SUBJECT: Park Roads
Section 2004-025 RS
Lake County
Contract No. 62745
Item No. 49, January 19, 2007 Letting
Addendum B

NOTICE TO PROSPECTIVE BIDDERS:

Attached is an addendum to the plans or proposal. This addendum involves revised and/or added material.

1. Revised page ii of the Table of Contents to the Special Provisions.
2. Added pages 123 – 126 to the Special Provisions.

SHEET 1 OF 2

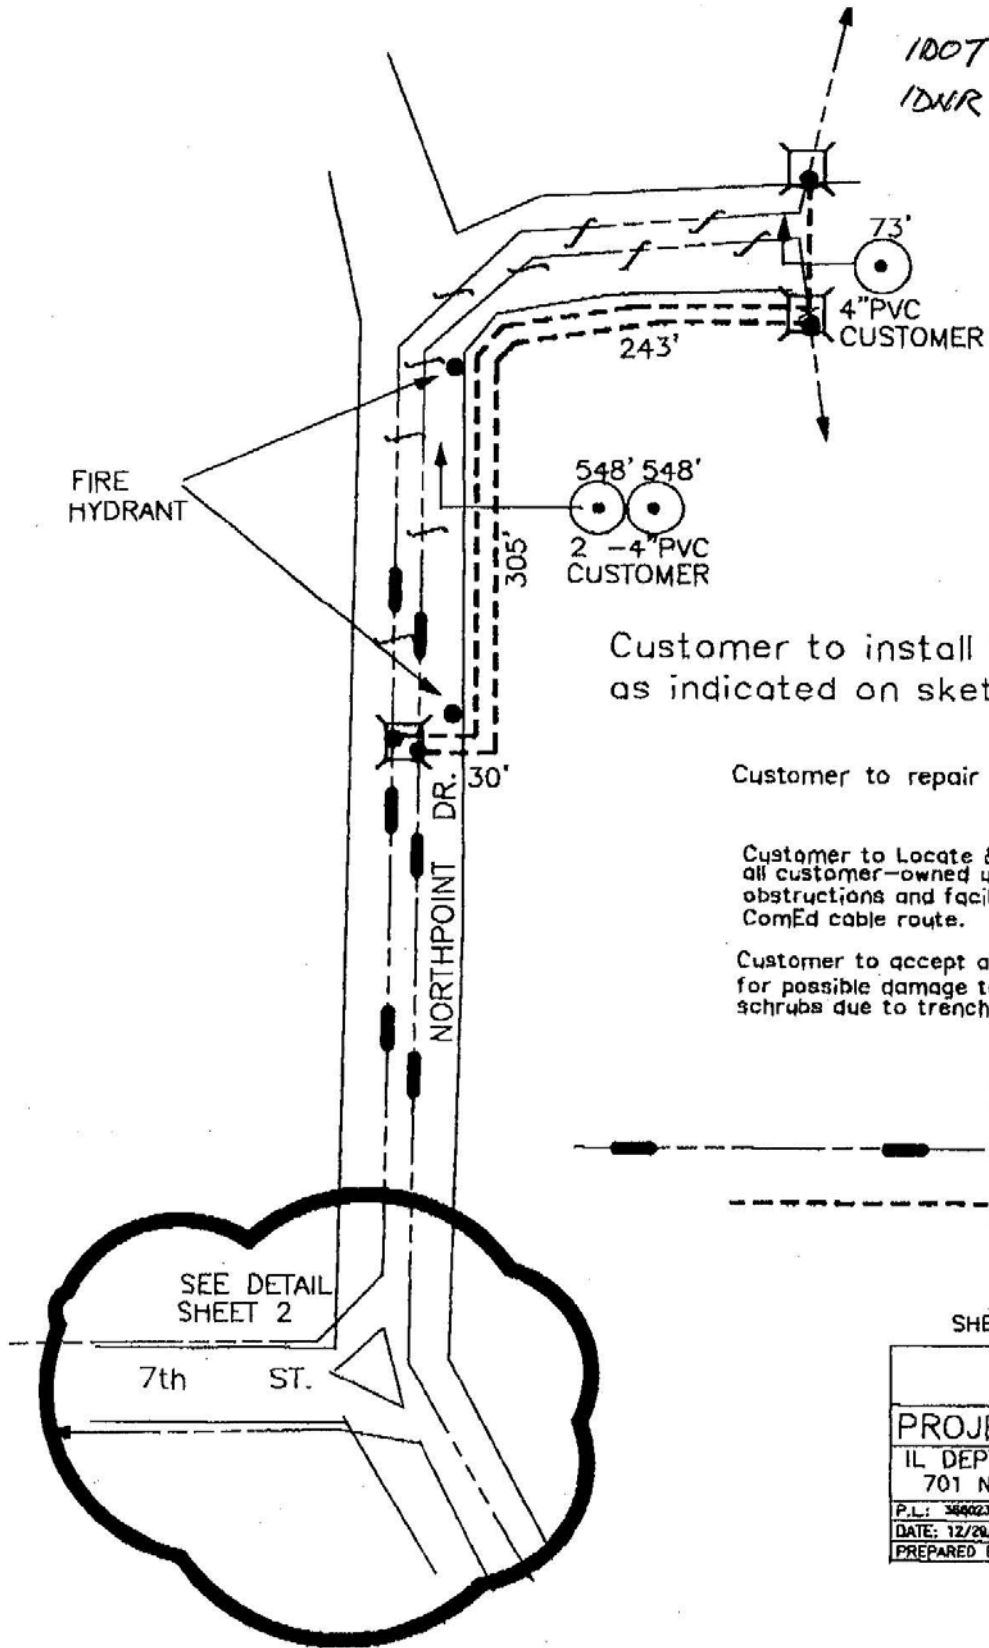
Customer to install 2 - 4" PVC as indicated on sketch

Customer to repair pavement

Customer to Locate & mark (stake) all customer-owned underground obstructions and facilities in the ComEd cable route.

Customer to accept all responsibility for possible damage to trees and/or shrubs due to trench work.

SHEET 2 of 2

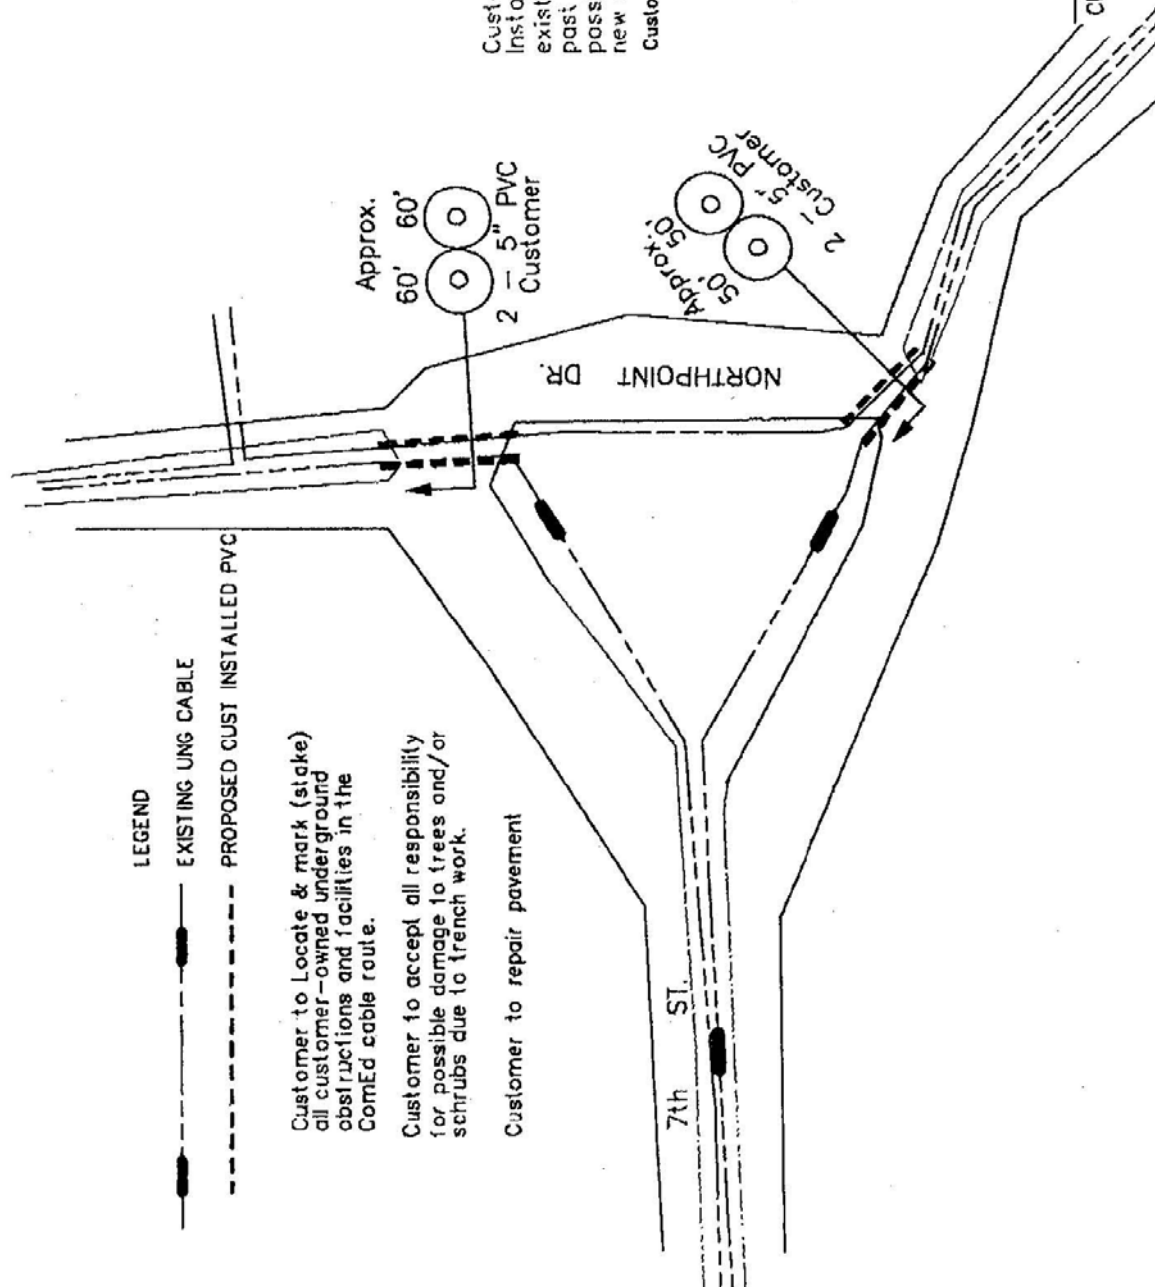
Customer contractors to:
 Install 2 - 5" PVC next to
 existing PVC and extend
 past existing PVC for future
 possible cable faults under
 new bituminous creos.
 Customer to repair pavement

Customer to locate & mark (stake) all customer-owned underground obstructions and facilities in the ComEd cable route.
 Customer to accept all responsibility for possible damage to trees and/or shrubs due to trench work.
 Customer to repair pavement
